Subject: Modeling Report Review Comments
Temporary East Culvert Causeway Closure, Great Salt Lake

The purpose of this letter is to provide DWQ and USGS review comments on the *Union Pacific Railroad Great Salt Lake Causeway Final Water and Salt Balance Modeling Report* dated April 4, 2014. The comments provided herein are from DWQ staff and are currently in review by DWQ management. DWQ concurs with the methods, results and findings as presented in the report and does not anticipate that the review comments will result in the need to recalibrate or rerun the model simulations. However, supplemental information and analyses are requested to further characterize the modeling results, limitations and uncertainty.

Re: U.S. Geological Survey Technical Review of the UPRR Great Salt Lake Causeway Bridge Construction Project Final Modeling Report

Fig. 1 – Asymptotic behavior of the water surface elevation under the dry, mild, and wet conditions for a period of 50 years.

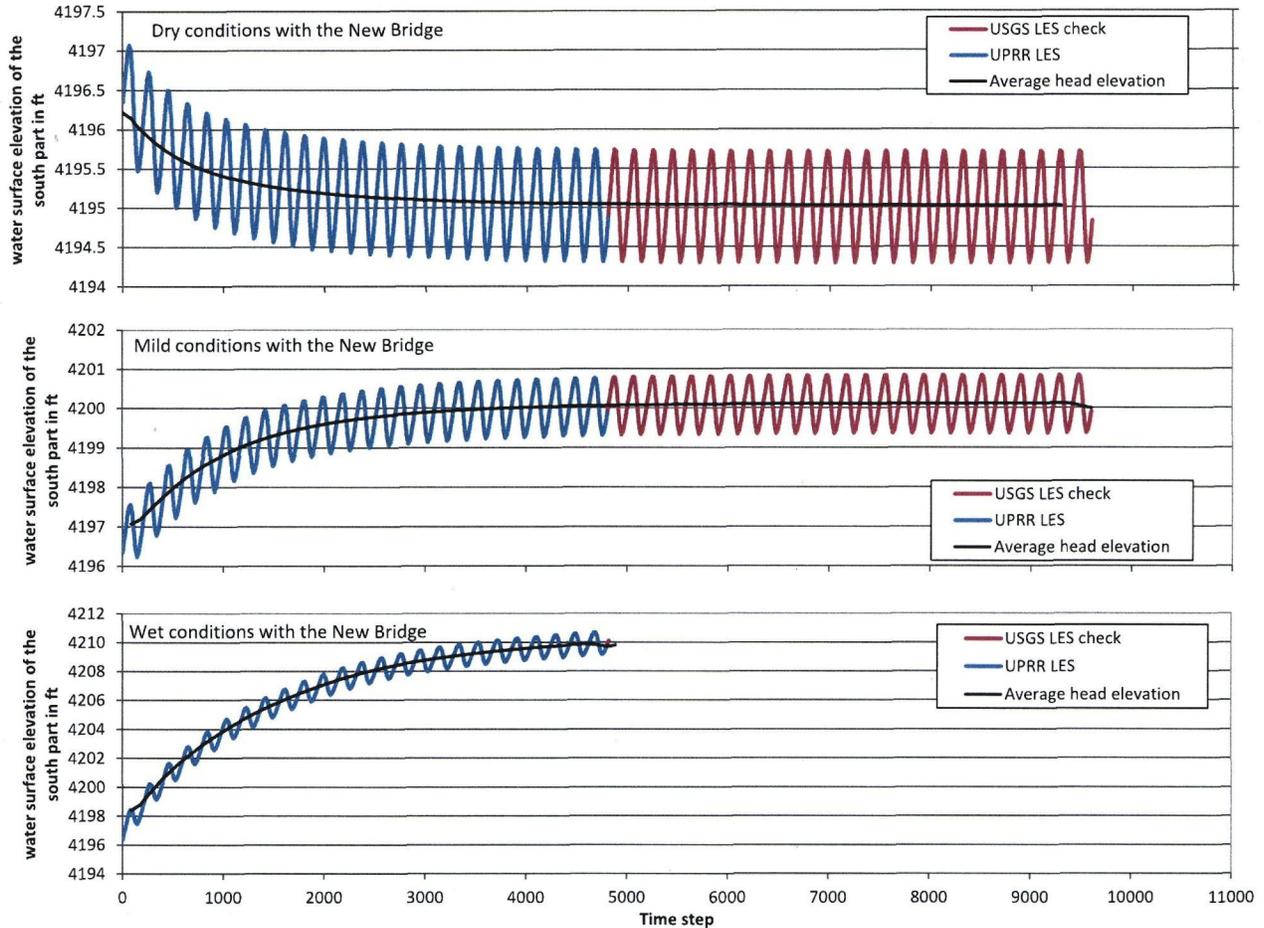
Step 3, pp. 27, sect. 6.0: The HDR modeling team assumed a 25 year period as sufficient to achieve a “steady state” condition in order to observe and compare model results under various lake levels. However, it is not clear from the summaries and depictions of model results if a “steady state” condition, or sufficiently close to a steady-state condition, is actually achieved in all cases. In particular, the wet simulation appears to continue to show change across time-steps at the end of the 25 year simulation. During our review, we took the liberty of continuing the simulations for dry and mild conditions through a period of 50 years (fig. 1). We were unable to complete a simulation of 50 years for the wet simulation as one of the model limitations, the computed head in the north arm must always be less than the head in the south arm, was violated at about the 26 year mark. We prescribed a gradient cutoff of 0.0001 ft/ time step as a reasonable approximation of stability; however, steady conditions are significantly greater. Our results indicated that when beginning with the same initial conditions for the dry simulation, this threshold would be reached at time step 2352 – or 12.26 years, well within the HDR 25-year simulation period. The length of time required for the prescribed stability threshold under the mild conditions is slightly greater at 19.13 yr (time step 3669). Assessment of the stability of the wet condition simulation; however, indicates that water surface elevation continues to rise and does not reach our designated gradient stability threshold by the end of the 25-year simulation (time-step 4889). However, during these wet conditions, the dissolved solids load in both the north and south parts (LN and LS) were fairly stable at a time-step of roughly 1350 or 7.04 yr. We suggest that the modelers expand their discussion of the selection of 25 years as the simulation period for comparison model results and suggest possibly documenting and justifying a criterion of change in computed model output values to assess the defined simulation period.

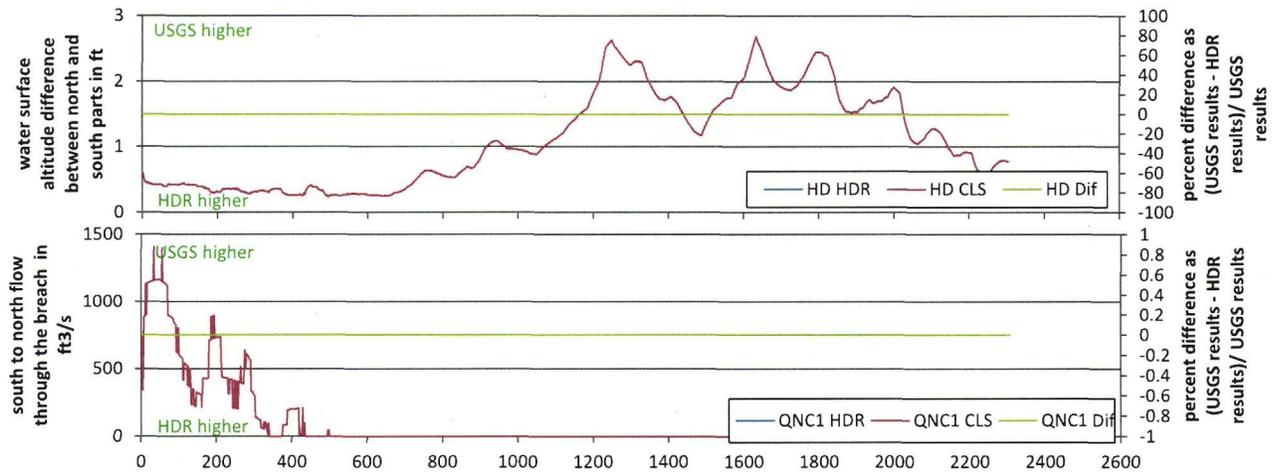
The separate and independent comparisons of HDR and USGS simulation results to the original model results of Loving and others (2000) for the culvert scenario from 1987 to 1998 indicated model-computed values for all parameters that were identical to the fifth decimal place. Both HDR and the USGS were able to exactly reproduce the results reported by Loving and others, 2000. An example is provided in fig. 2.

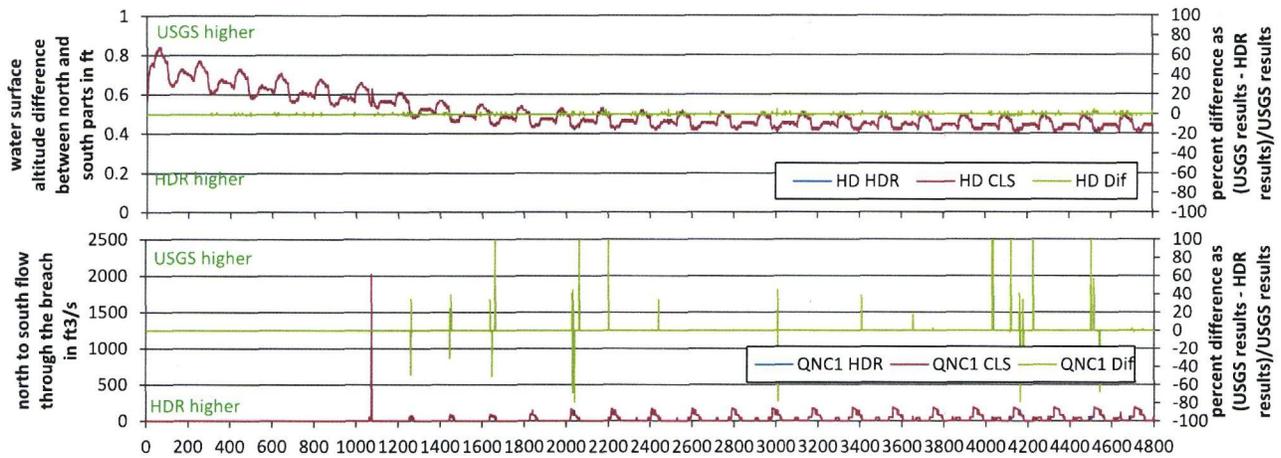
By examining the model output at individual time steps, our results revealed significant variations between the model computed values presented in the HDR reports and those obtained by the USGS. This was particularly evident in simulations that incorporated the implementation of the new bridge. Most of the simulations that incorporated the culverts (Step 1 Step 2) indicated a maximum discrepancy between HDR and USGS model results of 0.08%. However, model predictions produced in Step 3 for

the mild and wet conditions indicate much greater variability in flow results (i.e.: QSC(1), QNC(1) that occasionally reaches 100% difference in results (fig. 3).

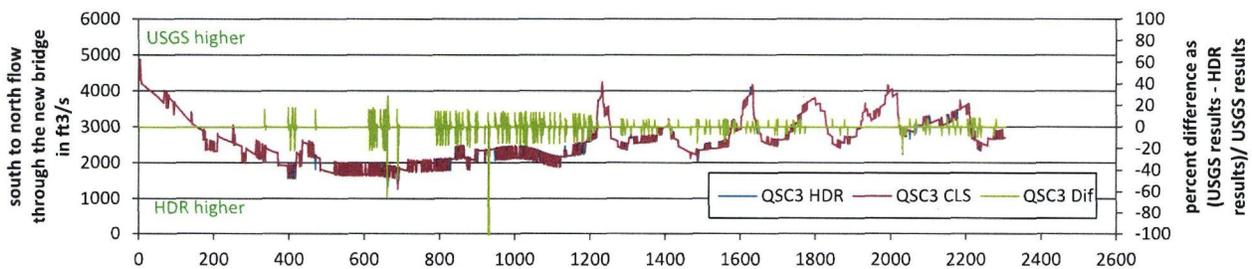
These observed variations are attributed to either Fortran compiler differences, computational precision variation between computers, or numerical dispersion by solution methods. Often, the computational precision of the computed value is decreased, causing what appear to be numerical oscillations about a mean value. Figure 4 provides a representative example of these numerical fluctuations (or dispersion) that are shown between timestep 513 and 1180 with an oscillation of about 15 percent. Some parameters such as the head difference between the north and south arm (HD; fig. 2) are presented as very fine or precise lines on the time series with no numerical oscillation. Other computed parameters, particularly the flow parameters like QSC3 (flow from south to north through the new bridge) present thicker lines for some timesteps, which is indicative of the numerical dispersion.

A more important concern is that the explicit incorporation of the Holley and Waddell (1976) equations into the model code induces increased uncertainty imposed on the result at any single timestep. The green line in fig. 4 shows that 56% of the simulated period, there was a deviation between the HDR and USGS model results. This deviation was often near 18% of the modeled results. This suggests that there is a considerable amount of numerical uncertainty in the computed results produced from individual computers using the exact same model inputs and codes, which would be expected to be exactly the same. If we zoom into a smaller period, we are able to identify this numerical uncertainty or dispersion (fig. 5).

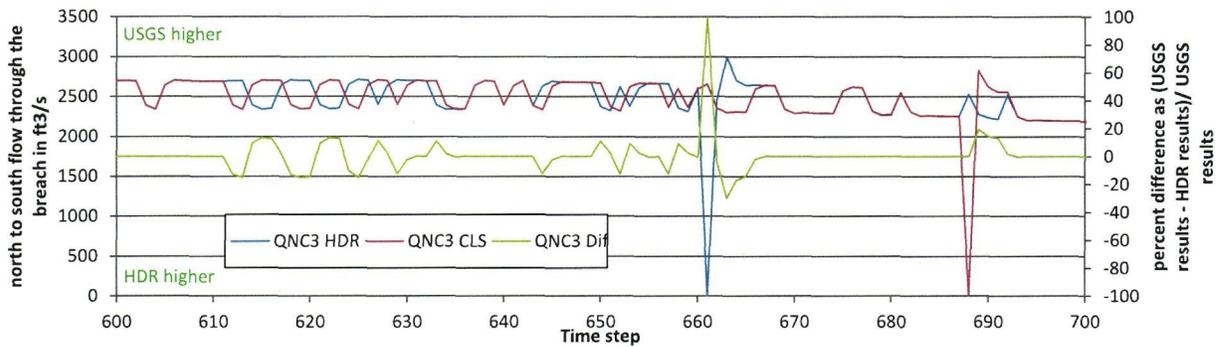
introduced by differences between Fortran compilers or computers. A representative example can be seen in fig. 5 at timestep 661 or 688.

By comparing fig. 5 from timestep 600 through 700, one can see that the numerical simulations performed separately by HDR and USGS are exactly the same. However, at timestep 611, the simulation results shift in phase until about timestep 636. This deviation produces nearly equivalent amplitude about the mean or uncertainty of nearly 15% and the phase shift attributes to the fluctuations in modeled differences. It appears that timestep 636 through 643, timestep 667 through 687, and timestep 692 through 700 are all exact reproductions between the HDR and USGS models. However, at the remainder of timesteps, significant and chaotic variations between simulations are observed. In fact, at timesteps 661 and 688, each of the model results provides a value of zero, which significantly increases the model uncertainty and creates model difference perturbations that last several timesteps.
